### **MEMORANDUM**

**TO:** Town of North Castle  
**FROM:** Eliot Senior P.E. L.S.  
**SUBJECT:** 1 Guion Lane  
**DATE:** August 7, 2023

**STORMWATER & EROSION CONTROL SYSTEM DESIGN "STORMWATER DETAILS"**

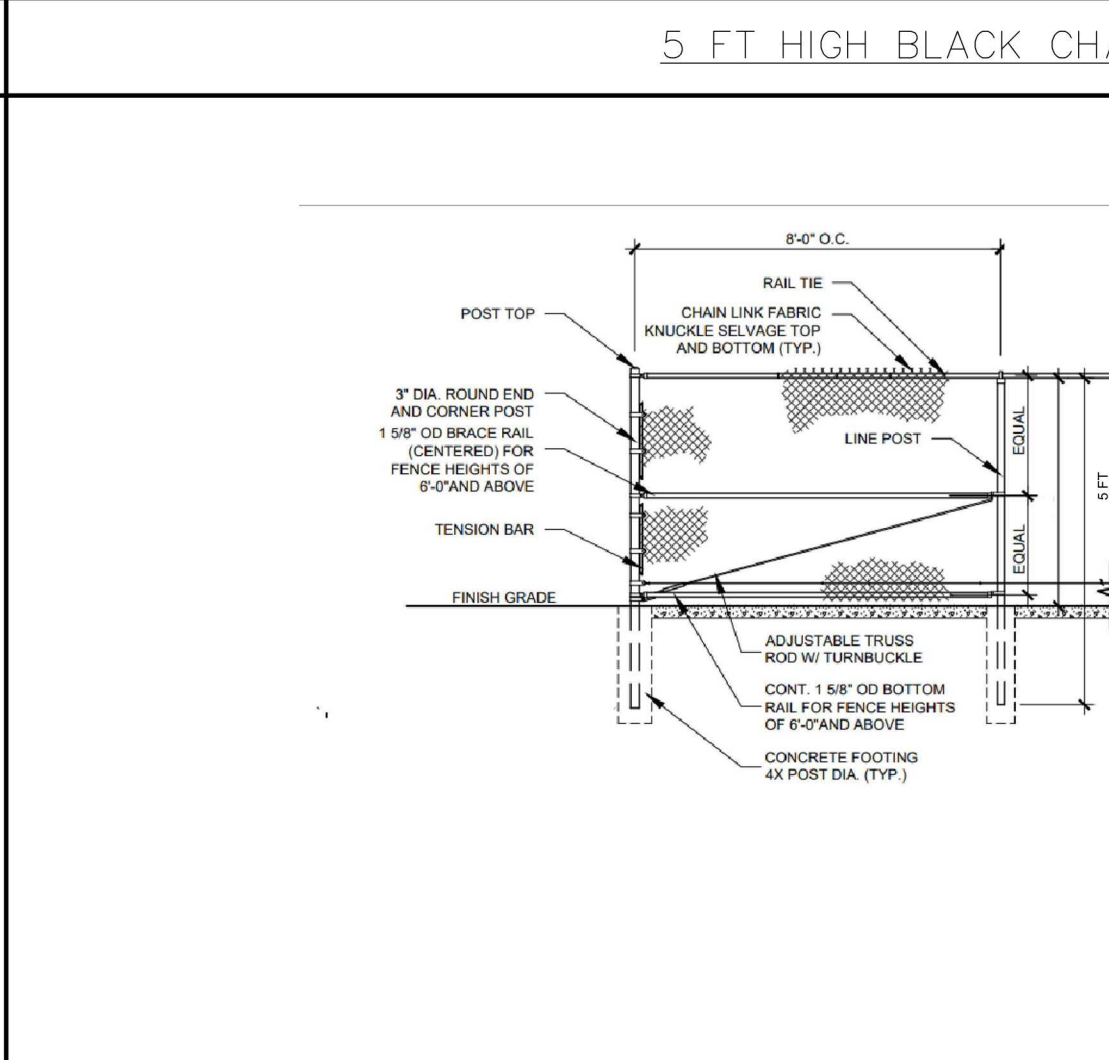
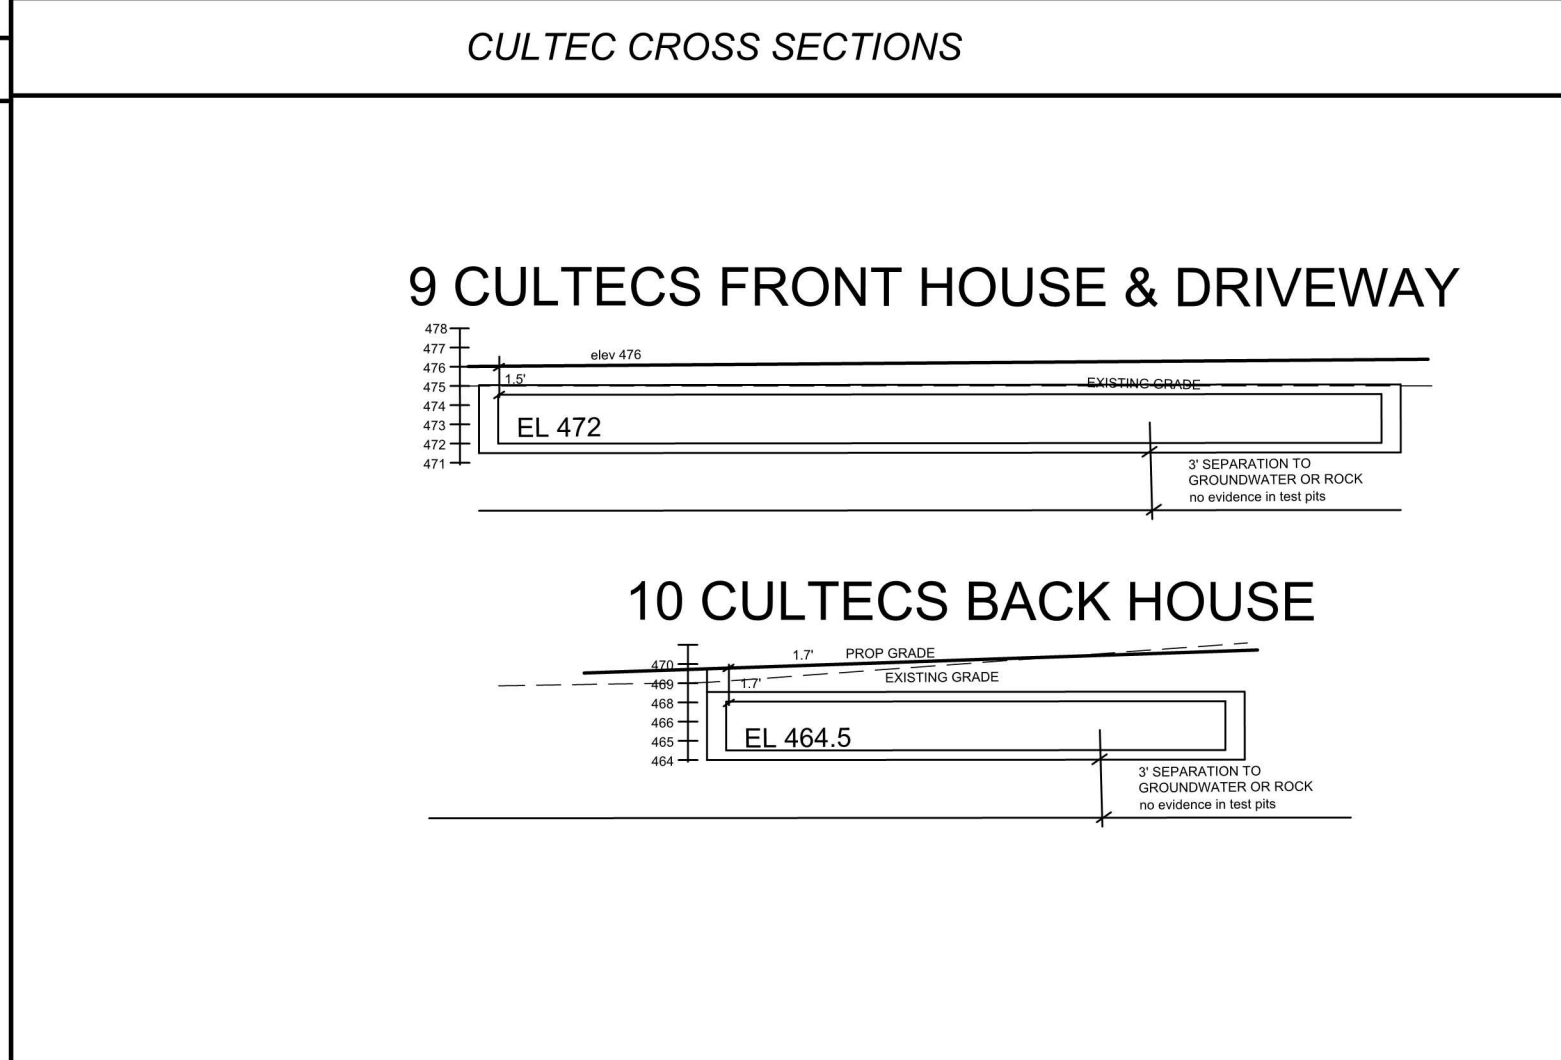
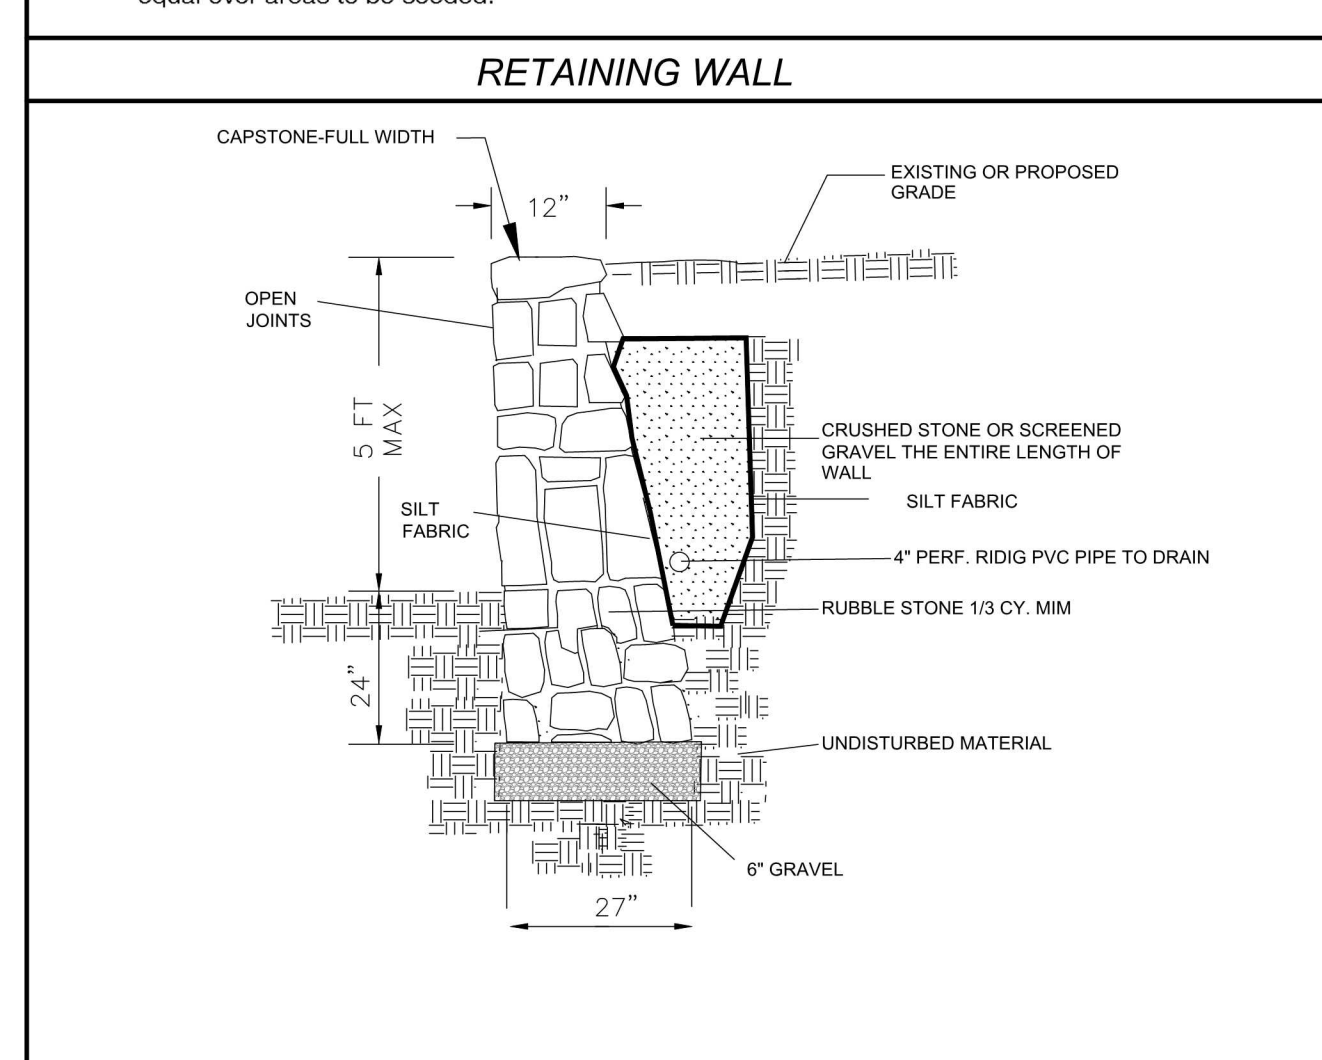
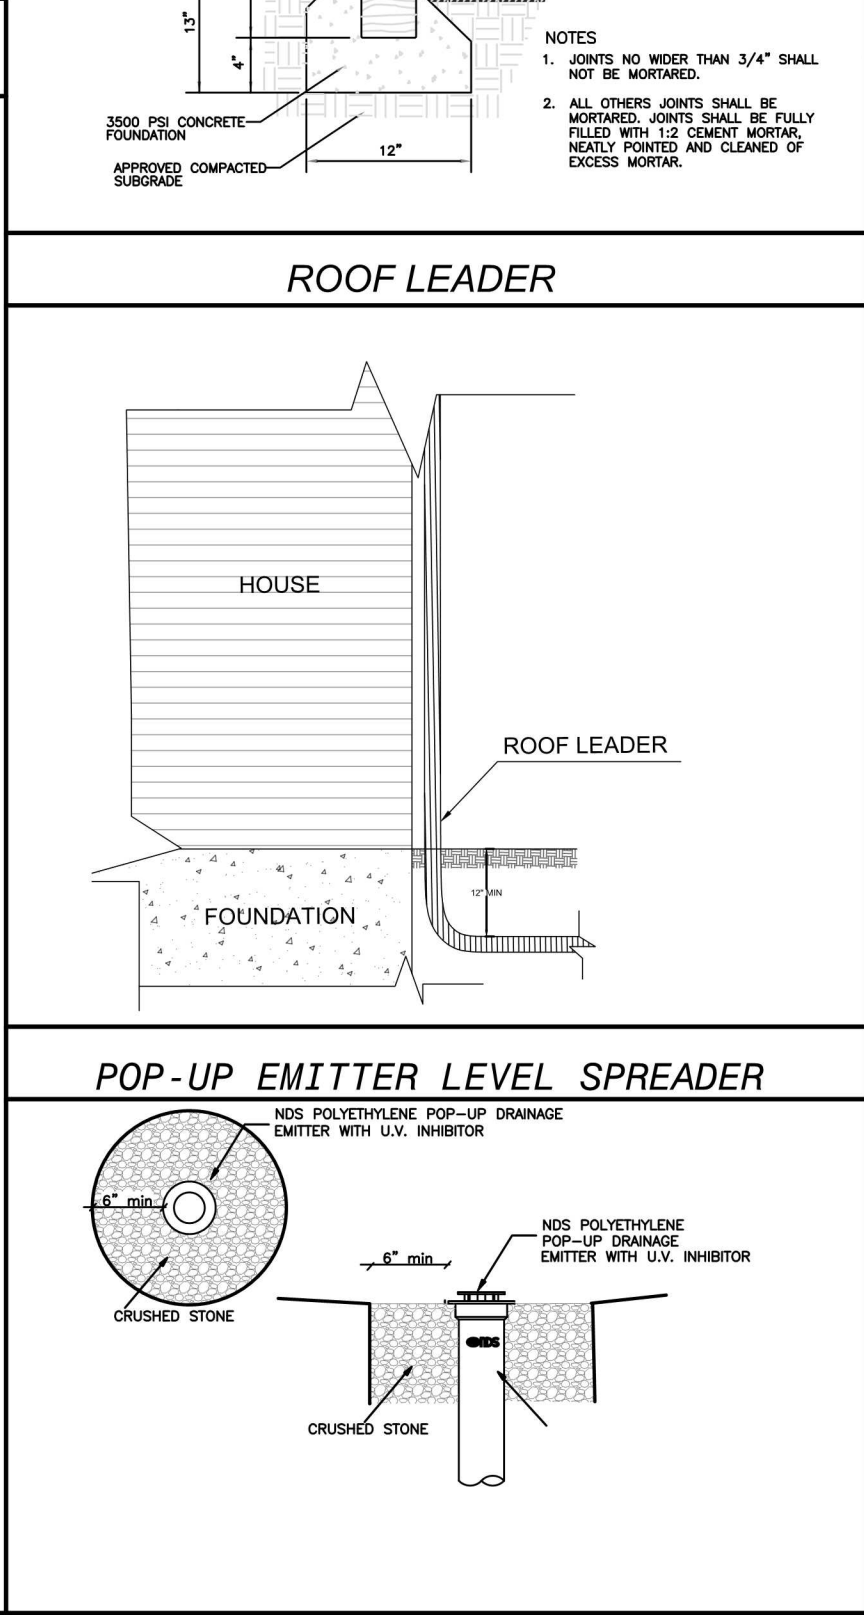
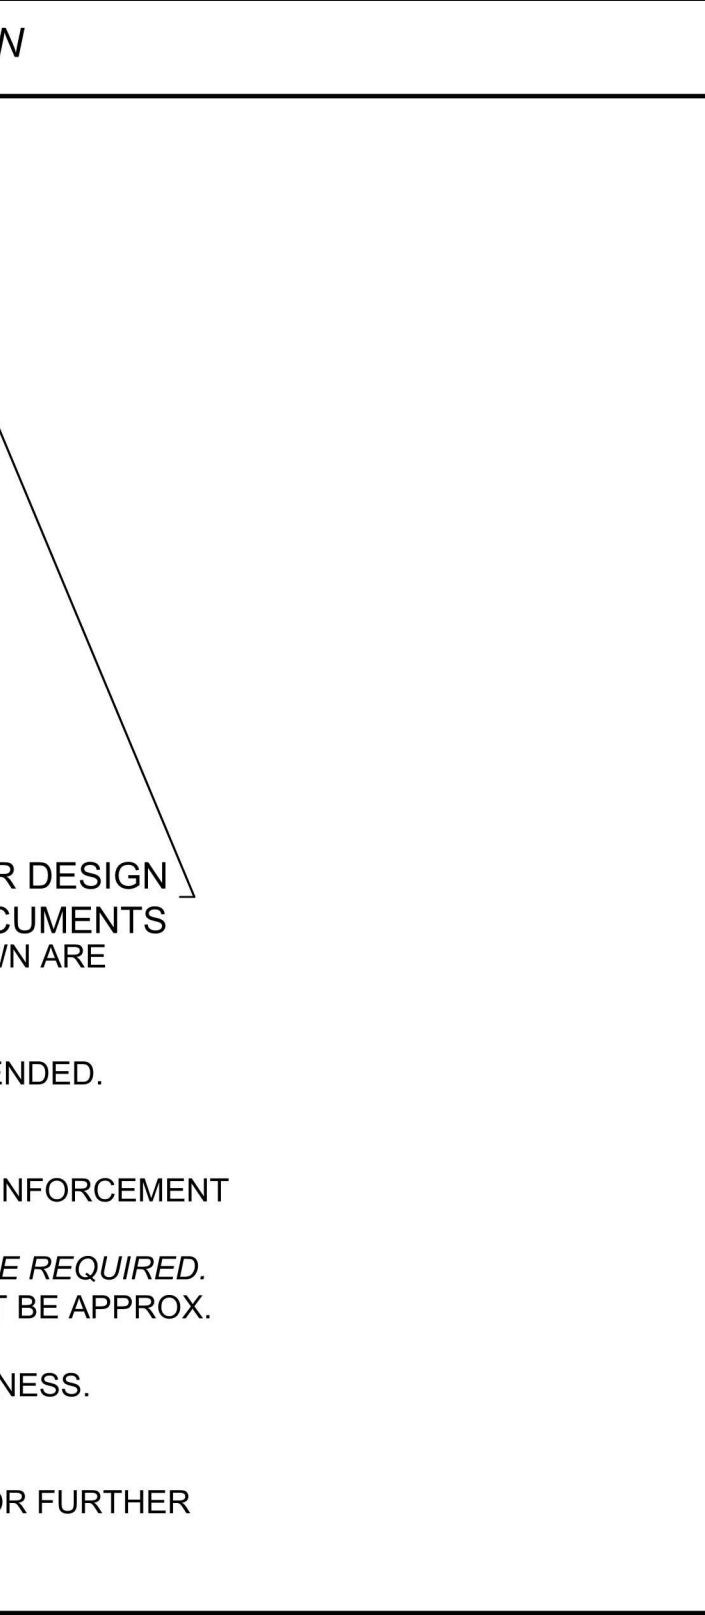
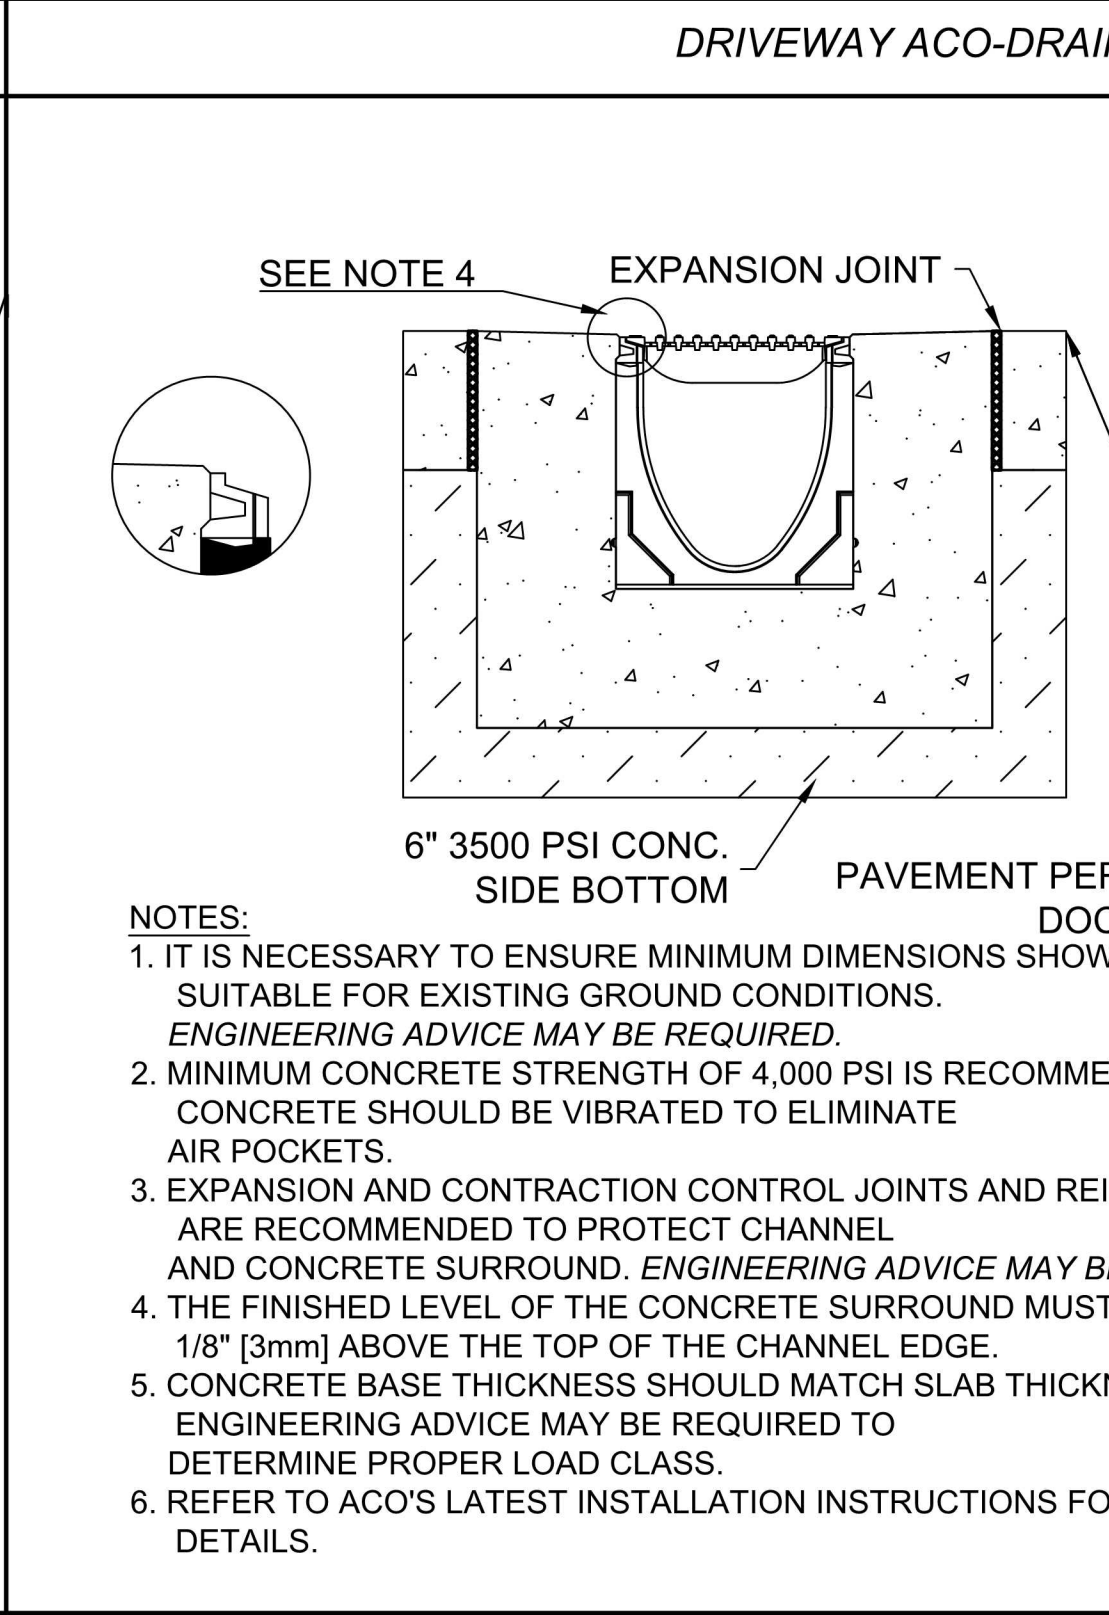
7. Please explain where the infiltration basin detail shown on Sheet D-1 is proposed on the drainage plan.

***Detail removed.***
